STAFF RECOMMENDATION 1712 Fifth Avenue North September 20, 2017

Metropolitan Historic Zoning Commission
Sunnyside in Sevier Park
3000 Granny White Pike
Nashville, Tennessee 37204
Telephone: (615) 862-7970
Fax: (615) 862-7974

Application: Addition and Alterations - violation
District: Salemtown Neighborhood Conservation Zoning Overlay
Council District: 19
Map and Parcel Number: 08205003400
Applicant: Saint Petka Serbian Orthodox Church
Project Lead: Melissa Sajid, melissa.sajid@nashville.gov

Description of Project: A cupola addition was constructed, windows replaced and brick cladding removed without a Preservation Permit.

ST PETKA SERBIAN CHURCH
 RENOVATION OF EXISTING
 CHURCH STRUCTURE
 NASHVILLE, SC

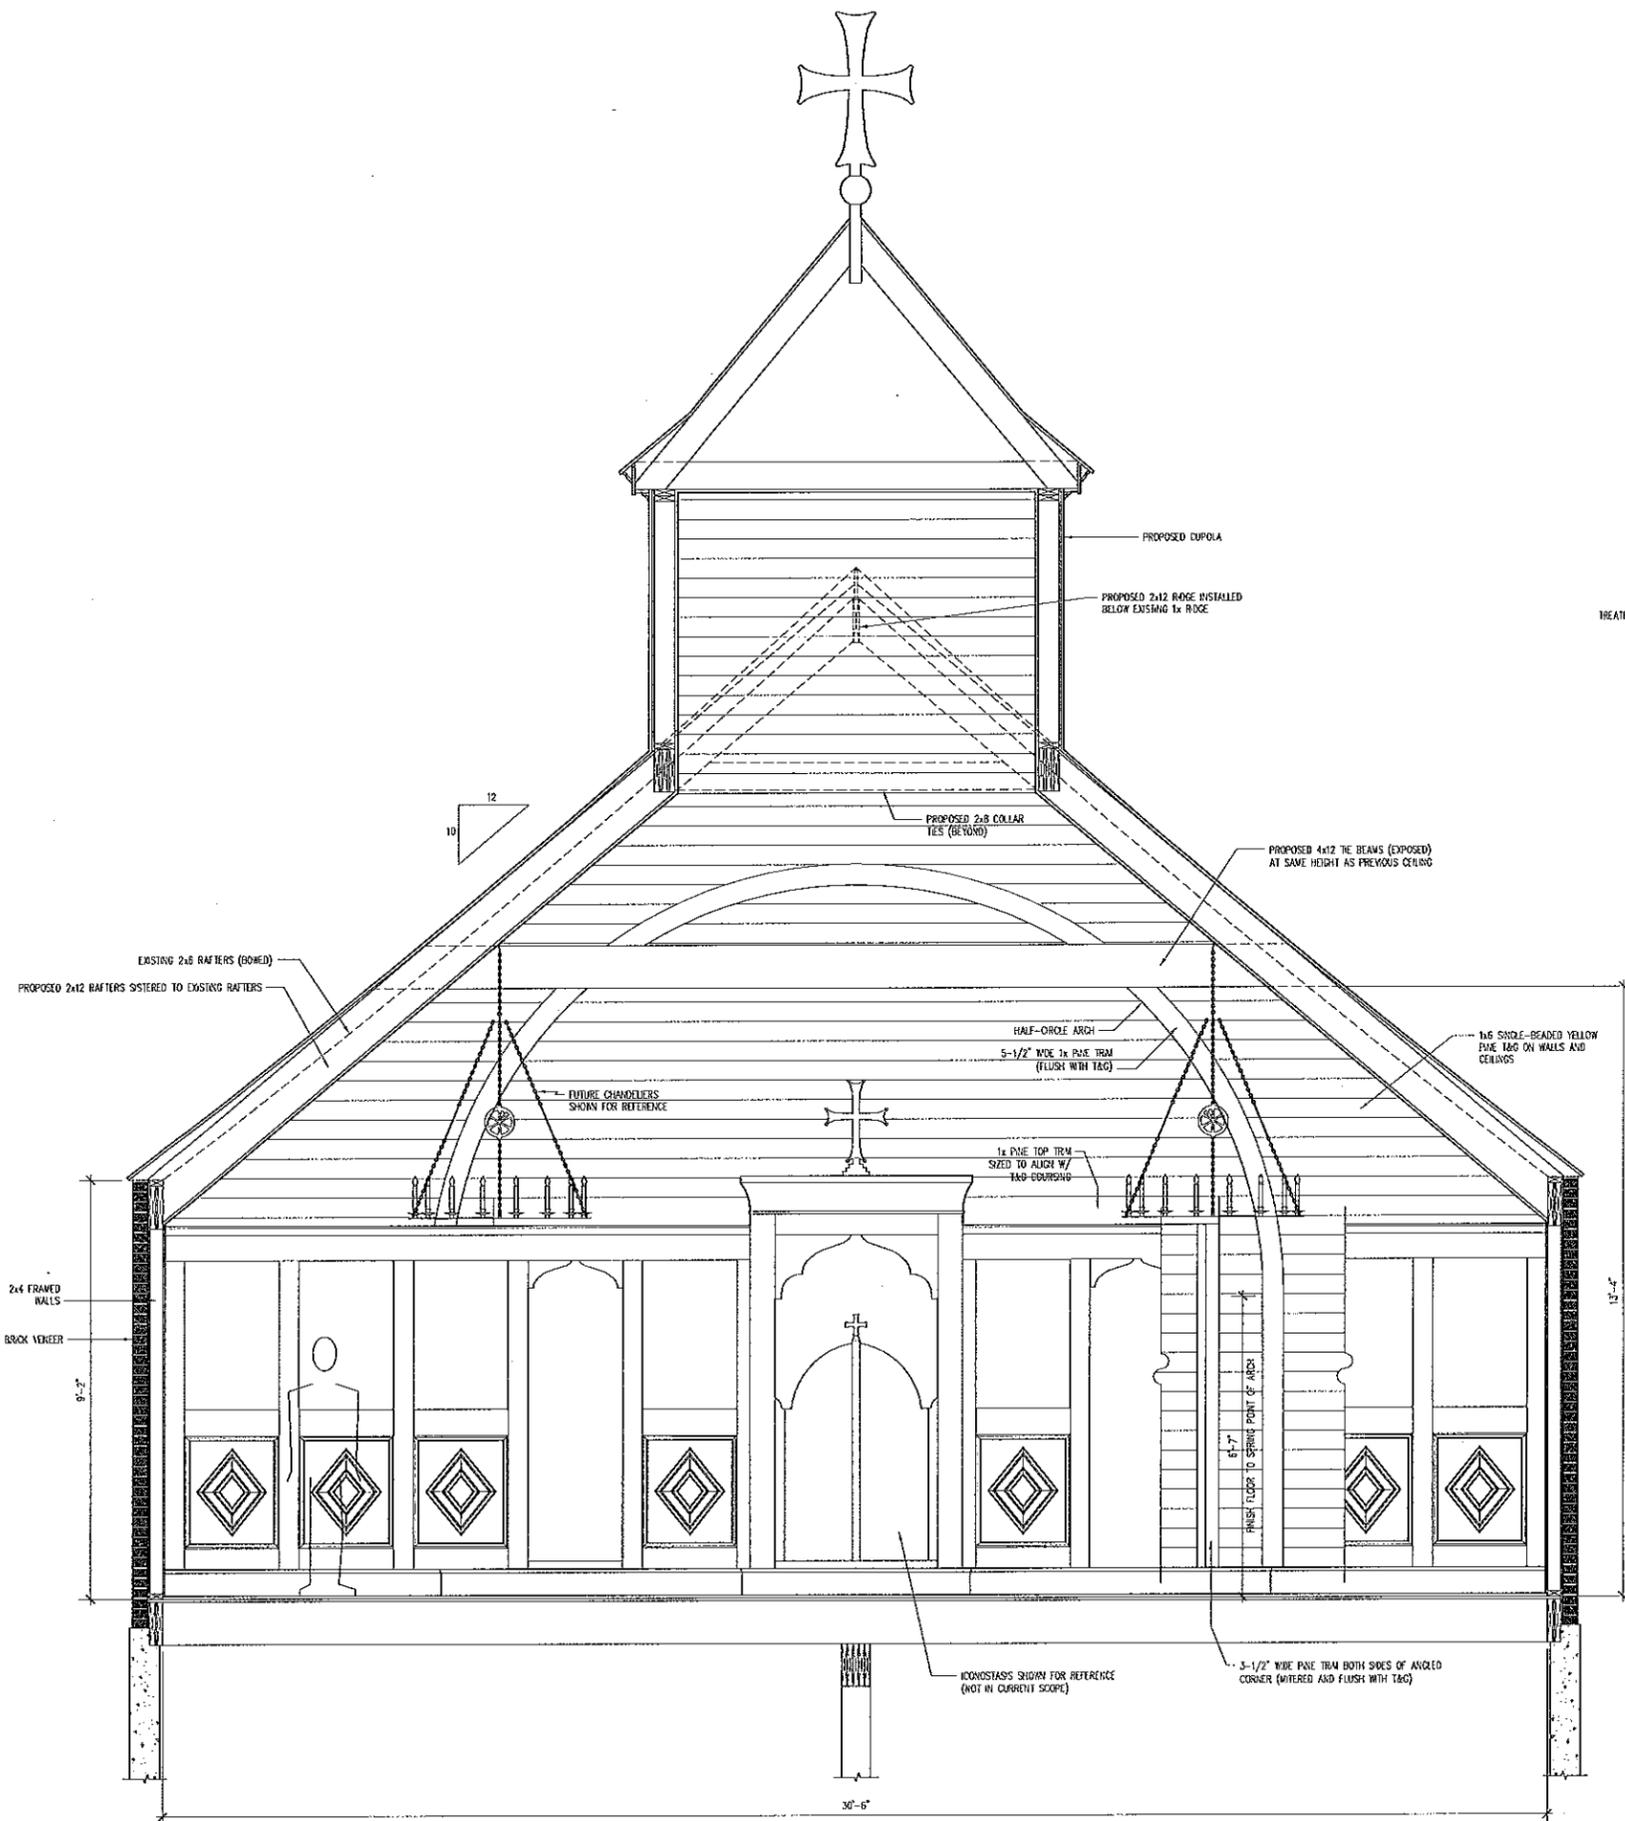
The applicant added a cupola to the primary roof of the historic church.

Location & Removability: The design guidelines call for additions to be located at the rear of buildings in a manner where it does not affect the historic form and character of the building. Cupolas are not listed as an appropriate type of rooftop addition. The Secretary of Interior’s Standards do not allow for the addition of “conjectural details.” Finding that the addition changes the historic building’s original form and design, the project does not meet section II.C. of the design guidelines for additions, II.A for location and I.B.3 of the Secretary of Interior’s Standards.

Design: Staff finds the design of the cupola to be inappropriate since it is not replicating a historic feature. The cupola contrasts greatly with the size and scale of the historic church. There is no evidence that the simple design of this historic church had a cupola. The project does not meet section II.E of the design guidelines.

All materials except for the windows meet the design guidelines. The applicant installed PlyGem 1500 Series vinyl windows, which the Commission has specifically not allowed. The project does not meet section III.D.

4. The cupola is removed and the original roof form restored to its original configuration with a roofing material to match the existing material.
5. The brick on the two sides of the historic portion of the church be altered so that the vertical stretchers that were located at the bottom of the brick wall (see figure 6) and above windows is reinstalled. No more historic brick is approved for removal.

6. The original window locations, dimensions, design and materials be reinstalled. The applicant shall submit drawings showing the original window dimensions and locations as well as information about materials for staff review, prior to making the change.
